Subject: 10CFR21 Reportable Defect  
Power Systems Division Reference No. 10CFR21-0050  
EMD 645E4 Tandem Air Start Control System

10CFR21 REPORTING OF DEFECTS  
AND NON-COMPLIANCE

COMPONENT: AIR START CONTROL SYSTEM  
DESIGN DEFECT

SYSTEM: DIESEL-GENERATOR UNIT  
USED AS STANDBY POWER  
SUPPLIES FOR NUCLEAR POWER  
GENERATING STATIONS

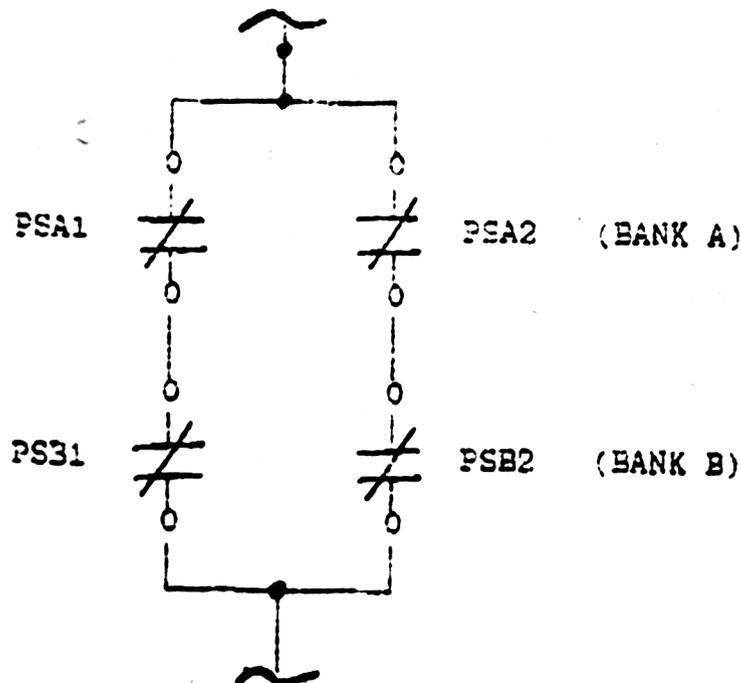
For the recycle feature to activate it would require that both sets of pinions in either the "A" or the "B" circuit to fail to engage. This would cause the recycling of the engagement. Experience has shown that the likelihood of both pinions failing to engage is a very remote possibility and that engagement is almost certain on the second attempt. Therefore, with both air receivers adequately charged with air, this does not appear to pose a safety related problem.

However, if one of the air supply banks is disabled and there is no air pressure in that system, then the one set of pressure switches would remain closed and cause relay TD to recycle continually and prevent the redundant system from completing its starting function. The diesel generator would be prevented from performing its safety function. The air receiver pressure is monitored so that loss of air receiver pressure would not go unnoticed.

An engineering study will be initiated by Morrison-Knudsen/Power Systems Division to provide a resolution to this problem.

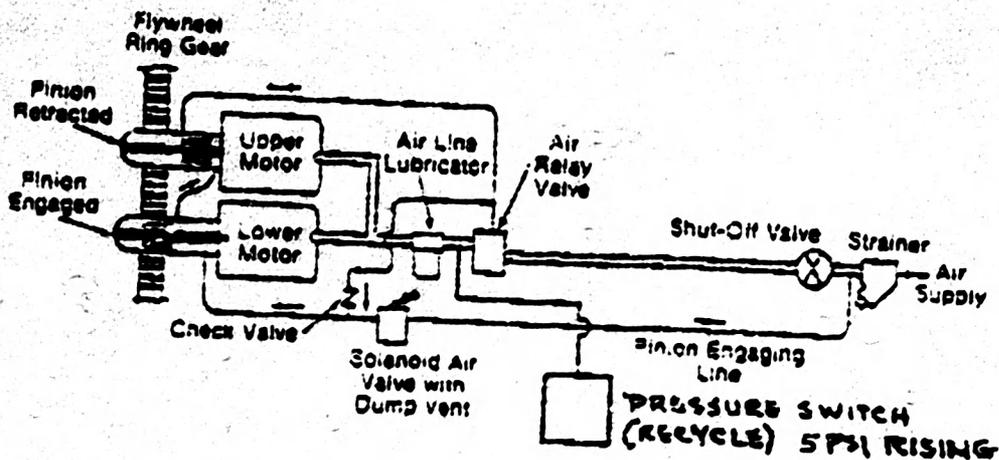
The arrangement of the pressure switches that monitor starting air pressure to the air start motors for tandem arrangement units shall be as follows:

If one bank (A or B) of air receivers were inactive for any reason such that air pressure were not available to its respective sets of air start motors, the pressure switch contacts for that bank would remain closed. Since it requires two of the four sets of air motors to start a tandem arrangement, both of the active set of air motors pinions must engage the flywheel gear. If only one engages, the system will recycle until both pinions engage. If one air supply does not have pressure, there will be no continuous recycle of the pinions and the diesel will perform its safety function.

If both sets of air receivers are active, then at least one air motor pinion from each parallel circuit above must engage to open the circuit to the recycling relays. If the two in series on one side engaged and the two in series on the opposite side did not, the system would also recycle until both parallel circuits have opened. Momentary recycling to get pinion gear engagement does not prevent the diesel generator from performing its safety function.

This arrangement effectively corrects the problem in the event where one set of the redundant air receivers or air supply is disrupted.

SIMPLIFIED TYPICAL CONTROL CIRCUIT FIG 2

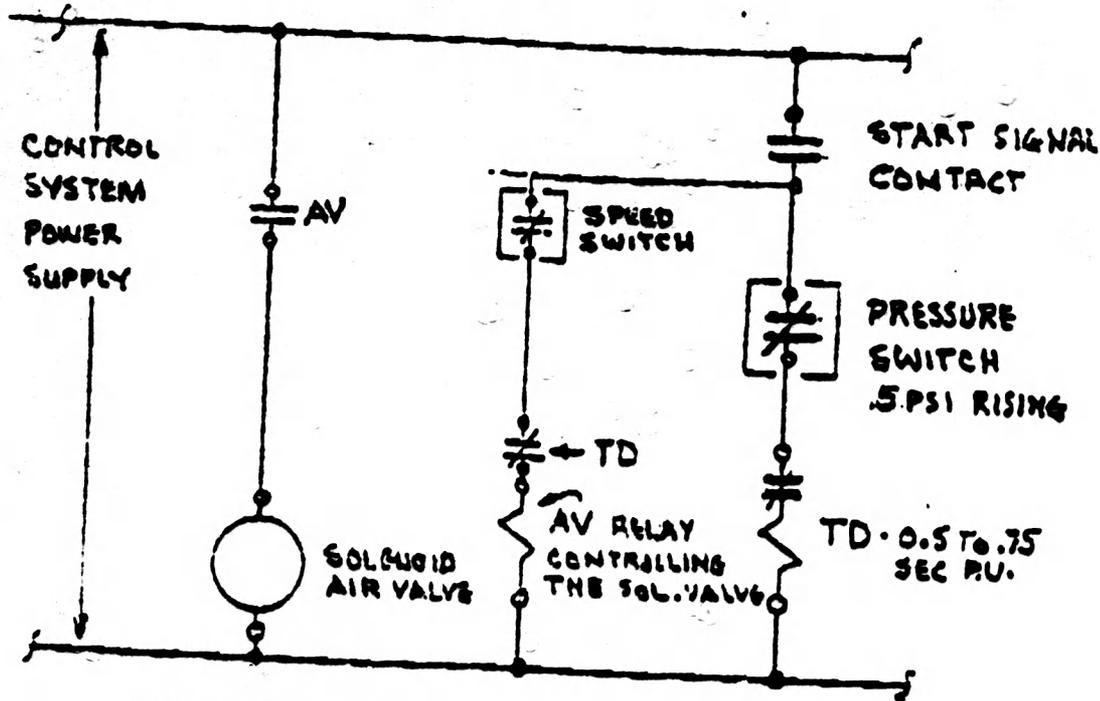
The contacts in the pressure switch are in series with a time delay relay in the starting control circuit. The time delay relay is set to pick up between 0.5 to 0.75 seconds after the start signal is initiated. When the time delay relay picks up, its contacts will open the circuit of the relays that control the solenoid air valve, causing the air valve to close and vent the line to the starting motor pinion engaging mechanism. This will cause the pinions to retract. When the time delay relay picks up, it will open one of its contacts in series with its coil and the relay will drop out and again complete the circuit to the solenoid

air valve for another attempt to engage the pinion gears with the flywheel ring gear and complete the circuit to the air relay valve to admit air to the air start motors. See Fig. 2.

**TYPICAL TANDEM ARRANGEMENT**

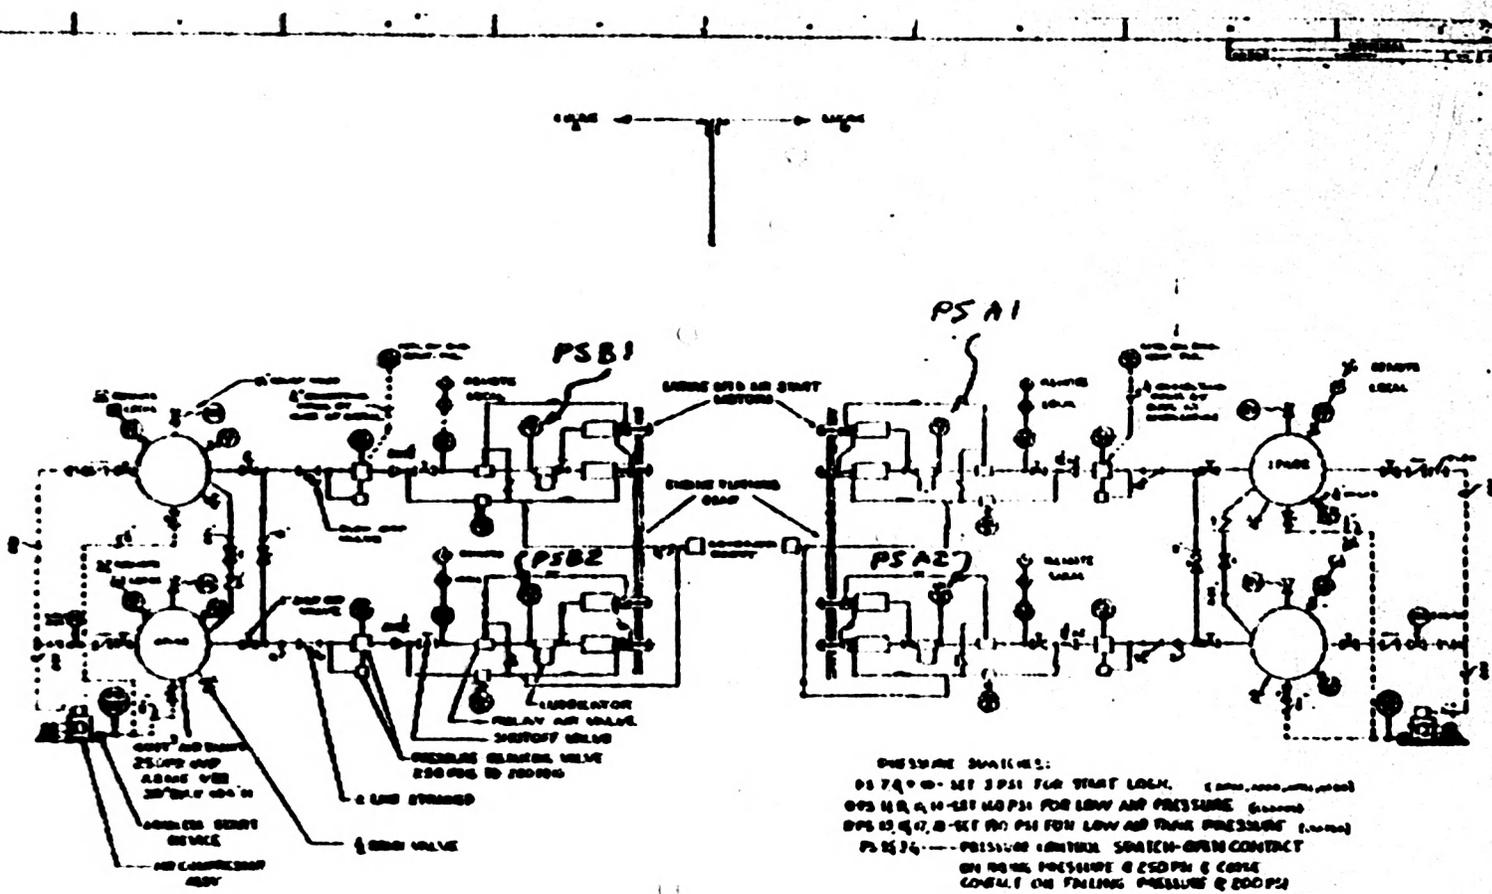
The arrangement for diesels in a tandem arrangement is shown in Fig. 4. In this arrangement, each one of the tandem engines has its own air receivers and two sets of engine mounted air start systems. In total, the tandem has two redundant sets of air receivers and two redundant sets of two air start systems or four sets of motors. It requires two air start motors to start the tandem arrangement.
